## Re: Causeway Street Reconstruction Project #606320

On behalf of LivableStreets Alliance, we are writing in regard to the 25% plans for the Causeway Street Reconstruction presented to the community on August 9, 2012.

Causeway Street/Keany Square plans from February 9, 2009

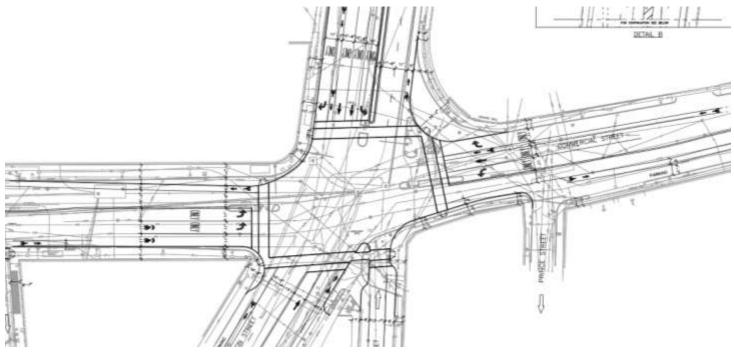
The design of Keany Square from the 2009 version of these plans was actually much better for pedestrian and bicyclists. It had eliminated the porkchop island on the northeast corner and had bike lanes on the N Washington St Bridge and on Commercial Street. The main improvement that we would make to this plan would be to either combine with the eastbound through lane or remove entirely one of the 2 left turn only lanes from Causeway St going eastbound, creating room for a continuous eastbound bike lane; we would also dash the bike lanes through the intersection.
